Access Compliance Report

Public Rights-of-Way

Intersection ID: 17080	Main Street: MARYLAND_AV	Cross Street: WESTFIELD_RD	Location: SE
ADA ID: 1085C22FF10D	Ramp Type: PerpDiag	Initial Pass/Fail: Fail	Overall Compliance: No
Codes/Mitigation Info/Possible Solution		Field Measurements/Component Compliance	
Severity Score: 8.75

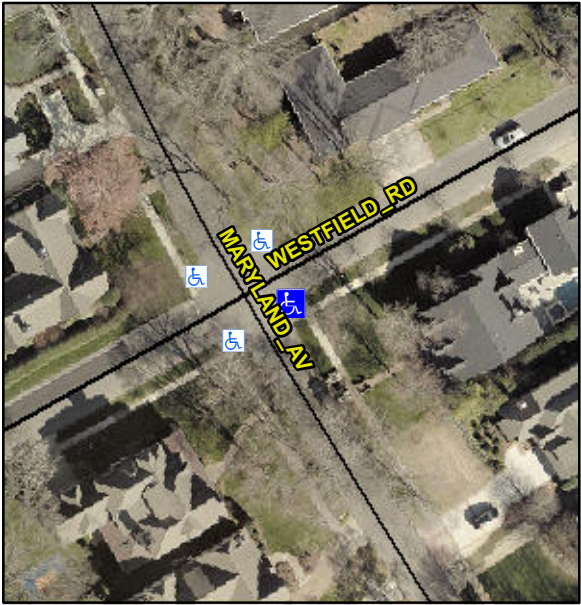
Possible Solutions:						
	Remove & Replace Curb Ramp With Two New Directional Ramps or Equivalent.	N/A	Ramp Length (in)	77.0	Yes	Ramp Slope (%)	6.6
		No	Ramp Width (in)	45.0	Yes	Ramp XSlope (%)	0.5
		N/A	Flare Type LT	N/A	N/A	Flare Type RT	N/A
		N/A	Flare Slope LT (%)	N/A	N/A	Flare Slope RT (%)	N/A
		N/A	Flare Traversable LT?	N/A	N/A	Flare Traversable RT?	N/A
		N/A	Landing Length (in)	N/A	N/A	DWS Provided?	N/A
		N/A	Landing Width (in)	N/A	N/A	DWS Contrast?	N/A
		N/A	Landing Slope (%)	N/A	N/A	DWS Length (in)	N/A
		N/A	Landing X Slope (%)	N/A	N/A	DWS Full Width?	N/A
<p>Surveyor Notes:</p> <p>N/A</p> <p>PROW/ADA:</p> <p>R304.5.1</p>		N/A	Landing Curb? (Y/N)	N/A	N/A	DWS Offset (in)	N/A
		N/A	Shared Landing?	N/A			
		N/A	Gutter Ponding?	N/A	N/A	Gutter Slope (%)	N/A
		N/A	Gutter Lip Ht (in)	N/A	N/A	Gutter X Slope (%)	N/A
		N/A	Painted X Walk1?	No	N/A	Painted X Walk2?	No
			X Walk 1 Direction	To NW		X Walk 2 Direction	To SW
